To: Mary Osman
From: Julian Wearne
Date: 19/02/2018
Subject: Strategic Transport Comments
Application No: PLN17//0991
Description: Construction of a multi storey building associated with the Australian Catholic University and alteration to Road Access.
Site Address 115 Victoria Parade, Fitzroy VIC 3065

Figure 1 – The south-bound bicycle lane should be extended with cyclists encouraged to separate from car traffic before the intersection. The raised pedestrian crossing should be treated to indicate is a shared space.

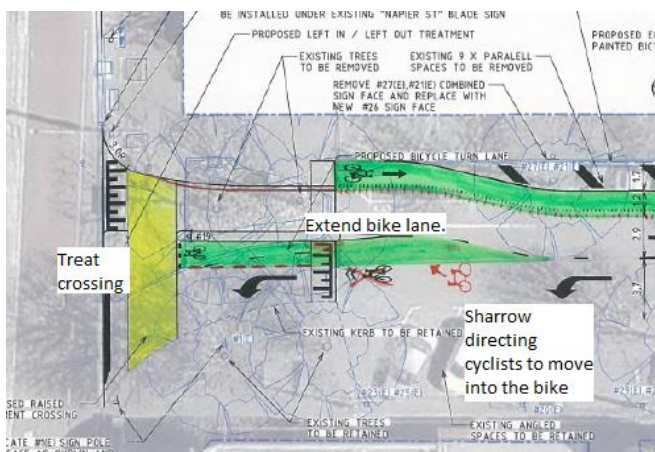
South-bound cyclists should separate from motorists before the intersection. This could be resolved by extending the green bicycle lane marking further north, and altering the bicycle sharrow near the intersection to indicate cyclists should move into the bike lane (Figure 1).

It is important to note the pedestrian crossing also forms a shared-cycling pedestrian space, given cyclists wishing to travel south down Lansdowne Street, or west along Victoria Street are required to turn right at the crossing to access the shared path (footpath) on Victoria Street. The crossing should be treated with a yellow surface treatment, sharrows and signage, to indicate it as such (Figure 1).

1. The north-bound bike lane on the west side of Napier Street, 1.5m wide or greater.
2. The south-bound bike lane extended further north to allow for cyclists to separate from traffic before the intersection. Sharrows should direct cyclists to move across.

4. The pedestrian crossing treated with yellow surface paint, signs and sharrows indicating it is a shared space.
5. Ramp gradients either side of the raised pedestrian crossing indicated.

Figure 2: Council's preferred proposed changes for Victoria Street.

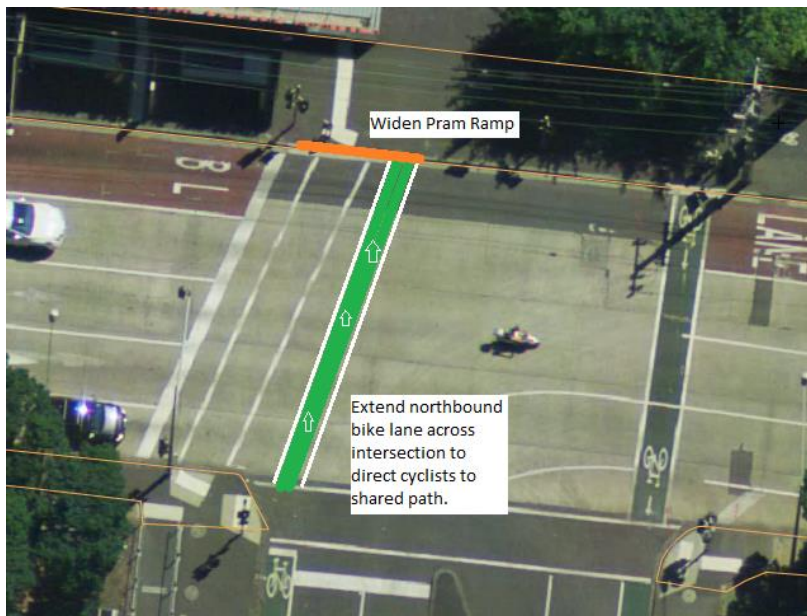
The proposal includes the removal of the existing car-park entrance and associated crossover at Victoria Street. Currently this crossover is being used by cyclists to access the shared path (footpath) at Victoria Street. Given this, pedestrian ramp (pram-ramp) at the north-west corner of the Victoria Parade and Lansdowne Street intersection should be widened, and the north-bound bicycle lane marking should be extended to the new pram-ramp.

3. The north-bound bike lane at the Victoria Parade / Landsdowne Street intersection extended to direct cyclists onto the shared-path. The associated pram ramp must also be widened.
